CROSSWALK AT COALFIELD ELEMENTARY SCHOOL

ADDENDUM #1

JUNE 26, 2026

THRASHER PROJECT #060-10301.01

SHEET No. 002

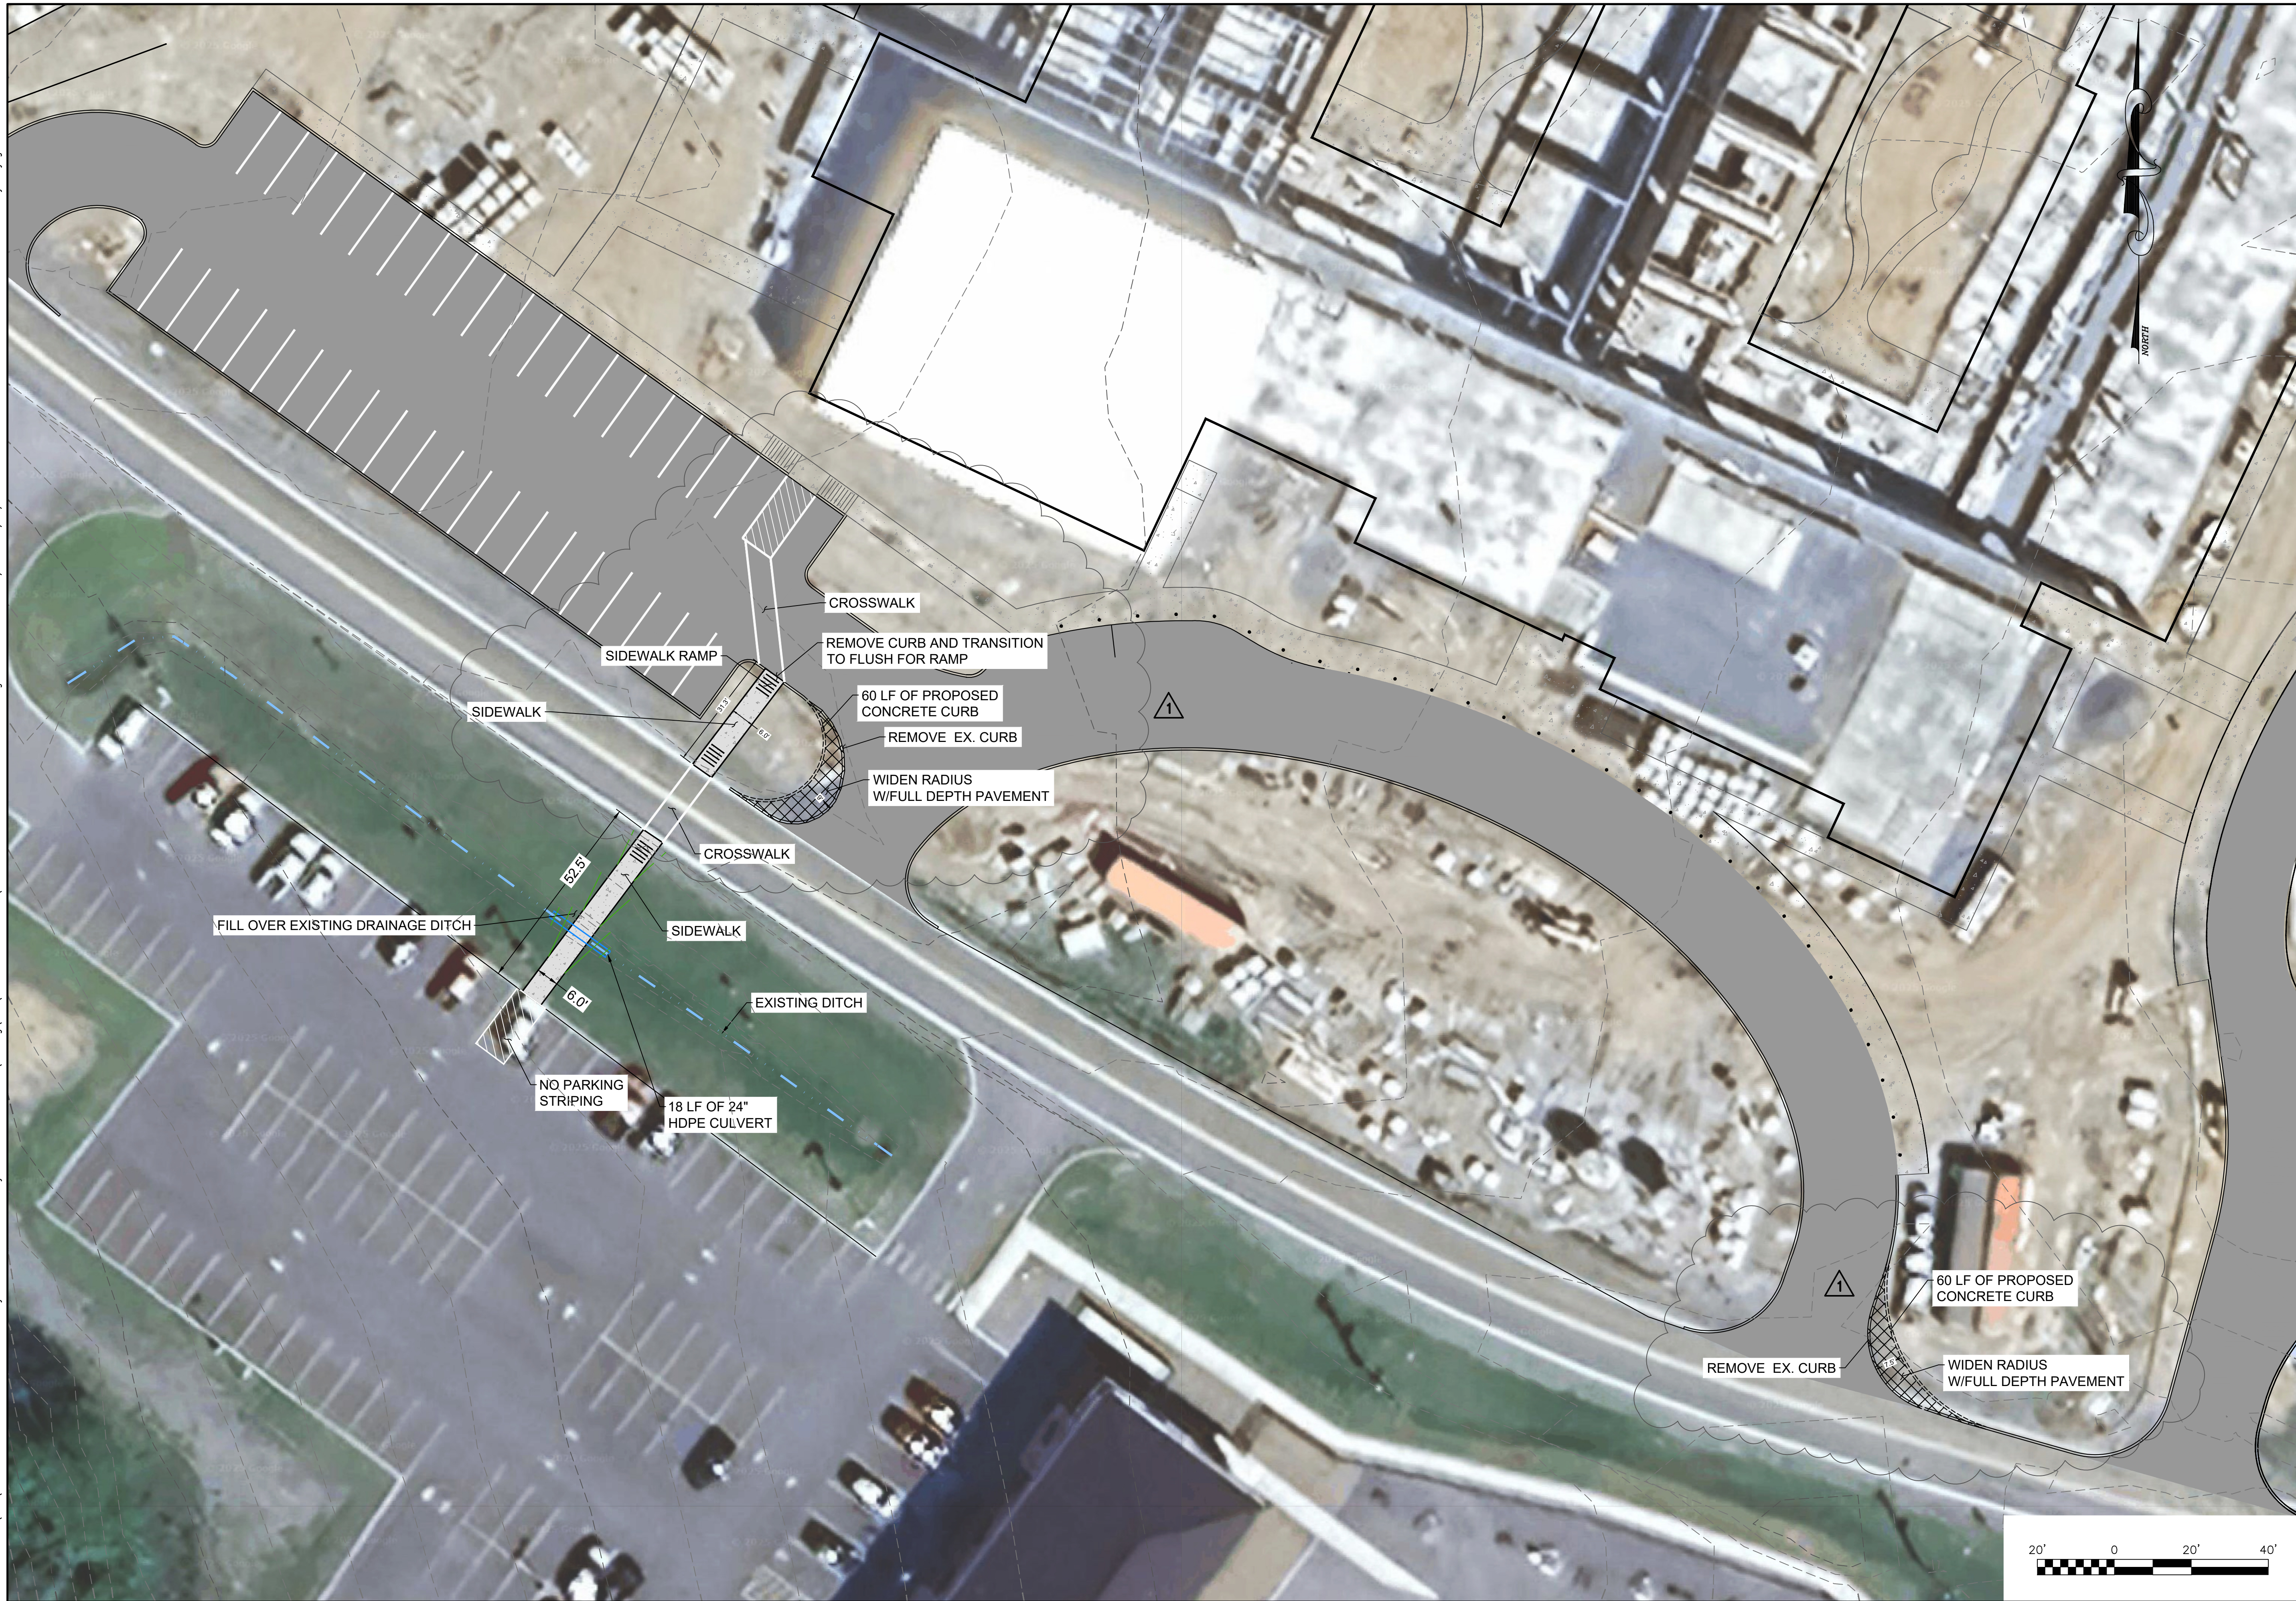
1. 002 General Notes & Quantities: Added notes and updated quantities.
2. 003 Site Crosswalk: Additional paving, curbing, etc
3. 004 Details: Added curb and pavement detail.

CIVIL SITE PLAN
 SHEET No. 003

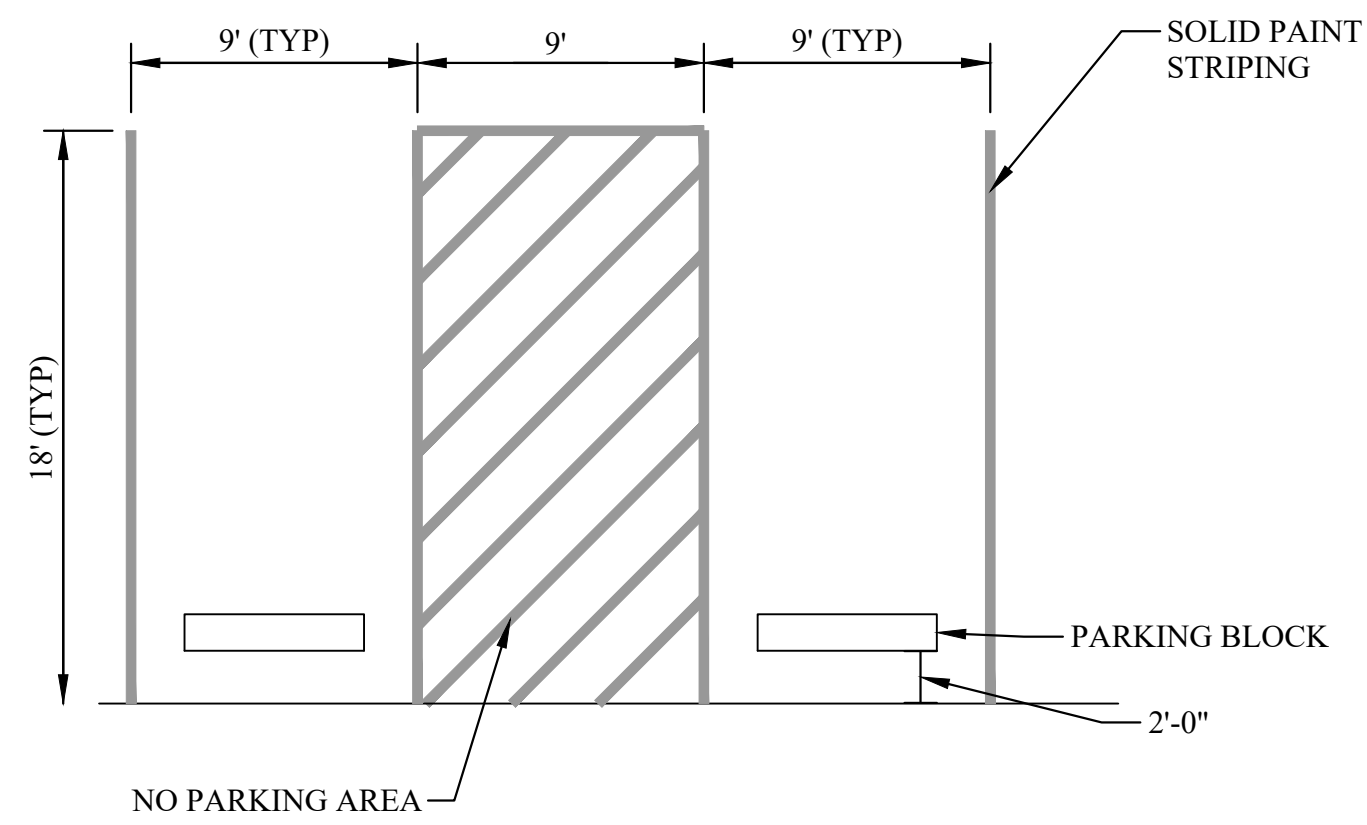
1. Once the new sidewalk gets to the school parking lot, the path will be directed to the existing ADA parking space ramp.
2. Detectable warning surfaces will be installed at the entrance/exit to the main access road.
3. Curbing and asphalt has been added to the bid item and plans for widening of the entrance/exit of the bus loop.

PLAIN CONCRETE CURBING TYPE I
NOT TO SCALE

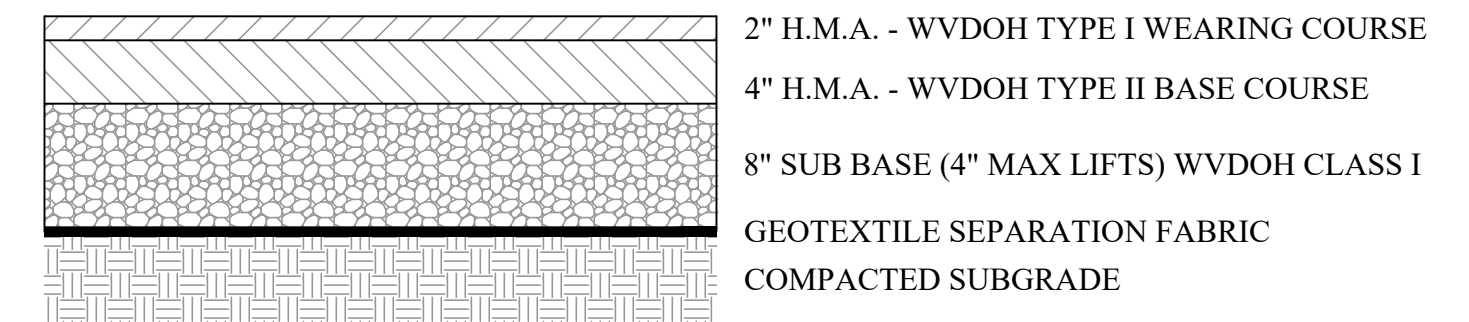
Do we need to remove and transition curb at the ramp?

Yes, the ramp must be flush with the asphalt and will require removal and transitioning of the curb. A bid item for concrete curb has been added to the bid form.
